DeKalb County Department of Planning & Sustainability

STAFF ANALYSIS

Case No:	Z-23-1246238	Agenda #: N2-2023-0065
Location/Address:	1422 Rock Chapel Road, Lithonia, 30058	Commission District:05 Super District: 07
Parcel ID:	16-189-01-003	
Request:	Rezone property from the R-100 (Residential Medium Lot-100) Zoning District to the M (Light Industrial) Zoning District for operation of a landscaping company and other site improvements.	
Property Owner:	Persiah G. Bedward	
Applicant/Agent:	Cornelius Ani / Land Engineering and Surveying, Inc.	
Acreage:	5.23 acres	
Existing Land Use:	Suburban (SUB)	
Adjacent Zoning:	North: R-100 (SUB) South: R-100 (SUB) East: R-100 (SUB) West: R-100 (SUB) Northeast: R-100 (SUB) Northwest: R-100 (SUB) Southeast: R-100(SUB) Southwest: M (LIND)	
Comprehensive Plan:	Consistent:	Inconsistent: X

ROCK CHAPEL LANDSCAPES

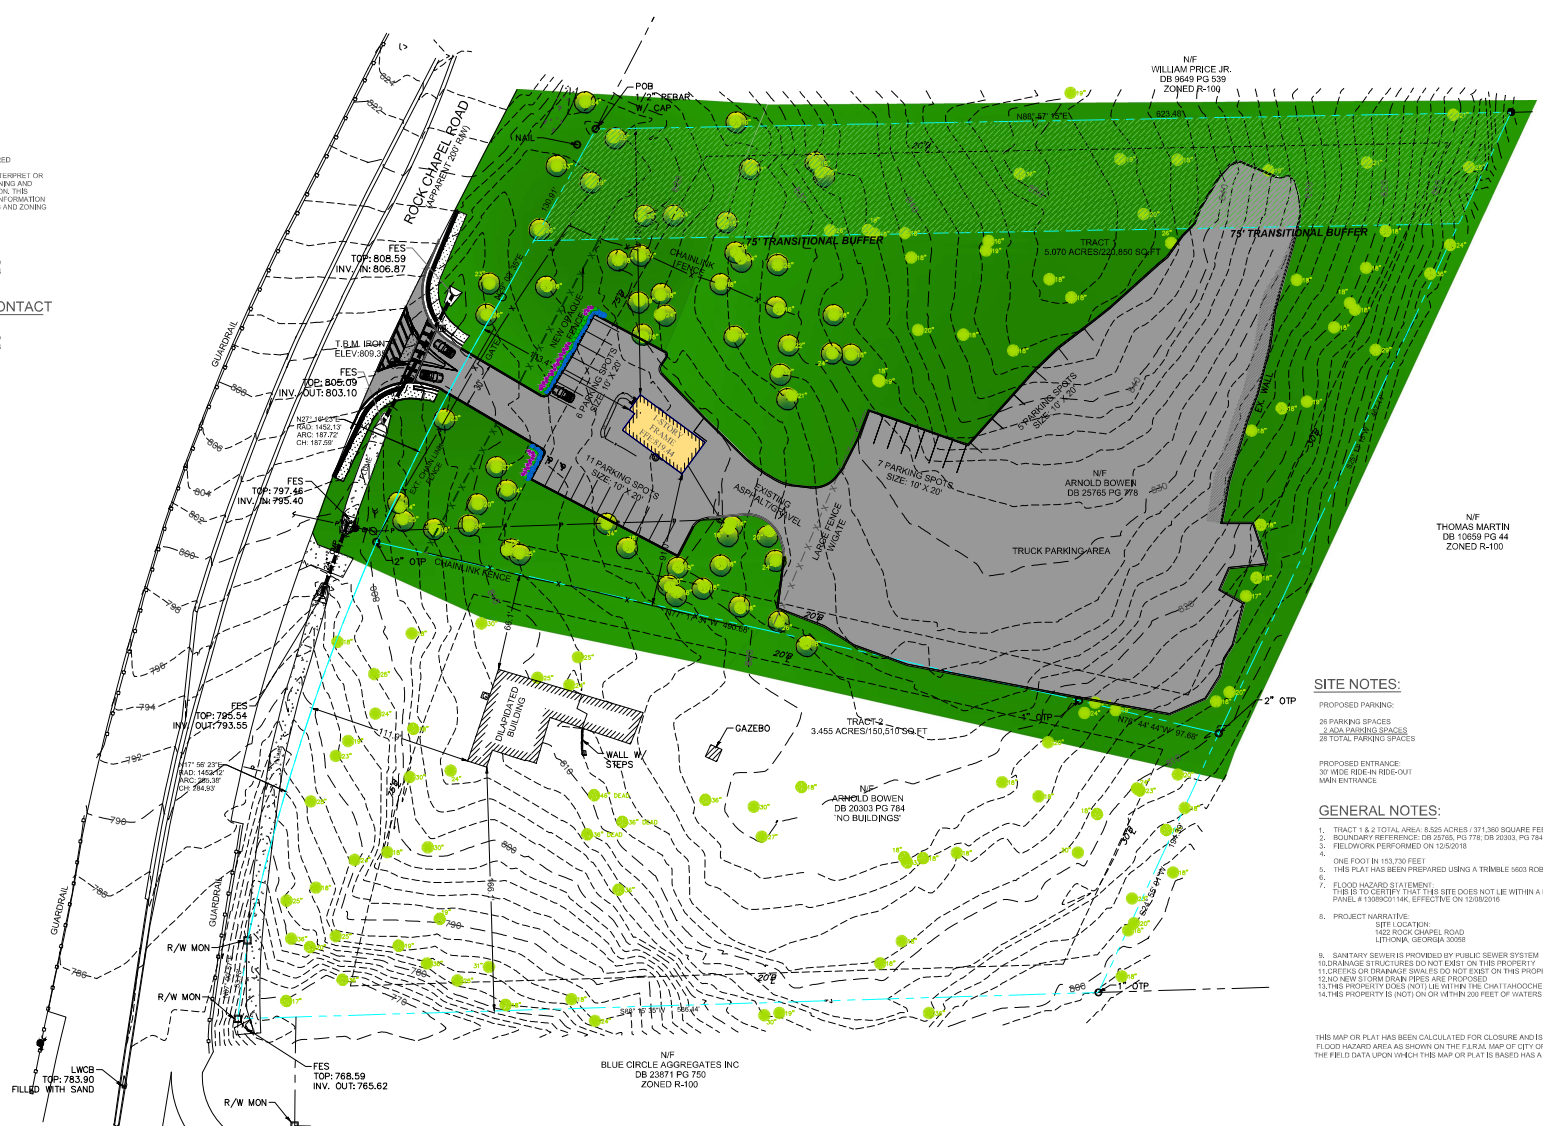
On the site plan submitted by the applicant, the applicant included the required 75-foot transitional buffer along the northern perimeter of the property but failed to include the same required 75-foot buffer along the eastern edge of the parcel, adjacent to residential R-100 parcels. The existing truck parking area in the southwestern corner already encroaches into this required 75-foot transitional buffer. An additional variance would be required for this parking area to remain. The southern edge of this same parking area encroaches into the side yard setback, this may also require a variance, unless the two (2) parcels are consolidated into one (1) large parcel. The site plan also fails to show the 5 (five)-foot landscape strip and the 10-foot multiuse path along Rock Chapel Road per GDOT (Georgia Department of Transportation) requirements.
